Docket Item # 4  
BAR CASE #2009-0070

BAR Meeting  
May 6, 2009

**ISSUE:** Alterations  
**APPLICANT:** Robert B. Adams and Associates  
**LOCATION:** 501 Wolfe Street  
**ZONE:** RM / Townhouse zone

Figure 8. East elevation with proposed alterations.

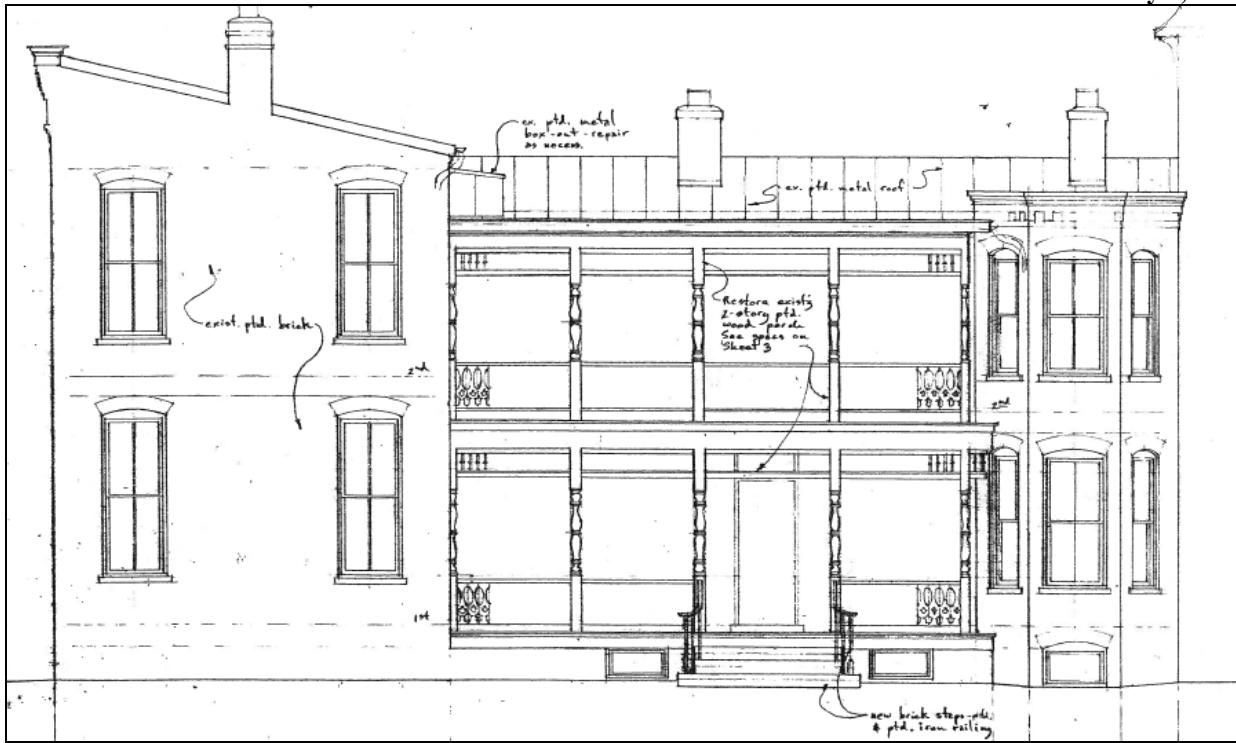
- Remove existing brick and concrete steps with iron railing
- Construct new brick steps with iron railing in same location
- Repair and restore two-story porch
- Add monitor window to second-story roof box

Staff notes that the existing roof box configuration is likely not original and was created to ameliorate an awkward situation (the top portion of the second-story window being cut off by the porch). The applicant is proposing to improve the roof box by allowing light into the interior through the addition of a monitor element. The proposed window will be installed on the north elevation and will be only slightly visible. The current roof box is painted a dark color to be as unobtrusive as possible and will continue to have the same color scheme. The *Design Guidelines* recommend that: “...windows should be appropriate to the historic period of the architectural style of the building.” The *Guidelines* also state that single-glazed, true divided light windows with interior storm sash are the preferred replacement window type. Staff supports the alteration to the roof box and the selection of a single-glazed, true divided light, wood window, finding the alterations to the roof box to be discreet and the proposed window to be an appropriate selection.

Figure 9. Section through porch looking south showing proposed alterations.

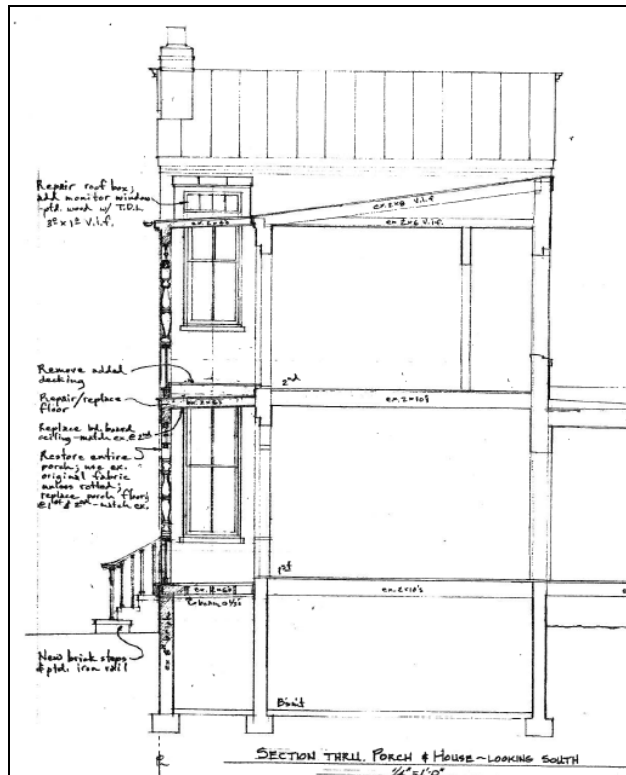
- Replace existing rotted porch flooring on first story and remove non-historic decking on second story
- Inspect all joists and beams and repair/replace as necessary and make porch elements level and plumb as possible
- Replace first floor ceiling with bead board to match second floor
- Inspect columns and bases for rot—repair/replace as necessary
- Repair/replace wood railings as necessary; repair balusters and replace missing pieces; remove non-historic bottom rail trim to improve drainage

The *Design Guidelines* note that “porches should be appropriate to the historical style of the structure” and “should be made of materials which are sympathetic to the building materials generally found in the historic districts.” Since the alterations to the porch are repairs and in-kind replacements as necessary, the porch and the alterations are consistent with the *Guidelines*. Staff finds that the proposed alterations related to the rehabilitation of the porch are all considered to be historically appropriate repairs and replacement, as necessary.

Figure 10. Plan of existing and proposed porch and stoop, first story.

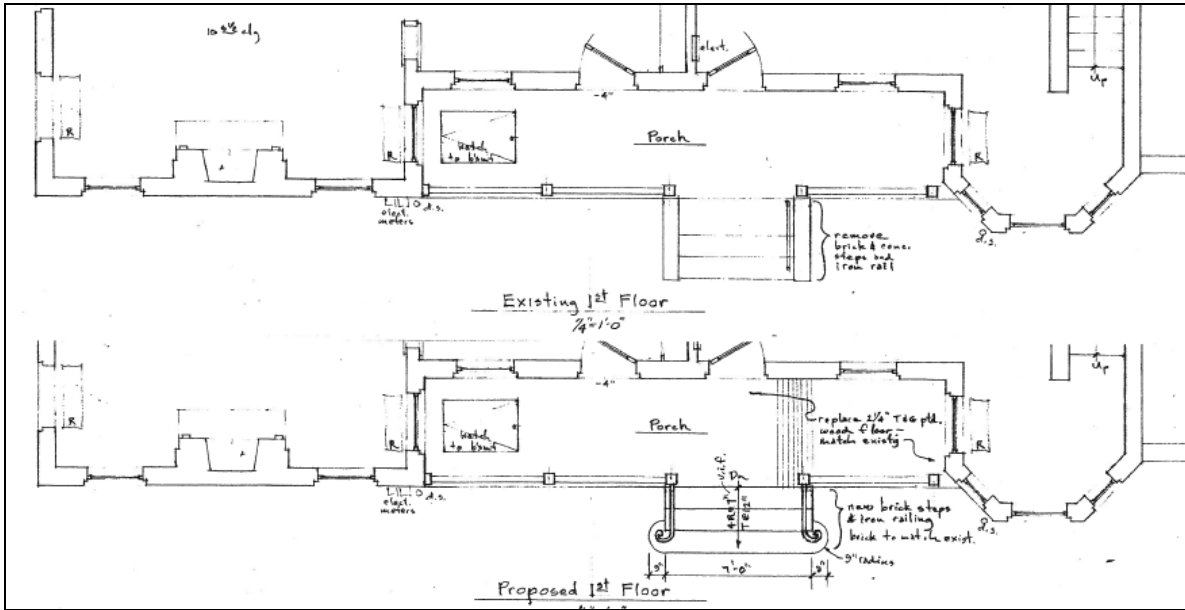
The applicant is proposing to remove the non-historic brick and concrete steps with iron railing and replace with, in the same location, and approximately the same size, a brick stoop with an iron railing. The lowest tread will extend slightly beyond the width of the stoop and the iron railing will curve accordingly.

The existing porch stoop, made of brick and concrete, does not appear to be historic. The proposed brick stoop is consistent with the *Design Guidelines* which state that “stoops, steps and railings should be made of materials which are sympathetic to the building materials generally found in the historic districts” and “should be appropriate and compatible with the historic architecture of the building.” Staff finds that the proposed brick stoop with simple iron railing is appropriate.
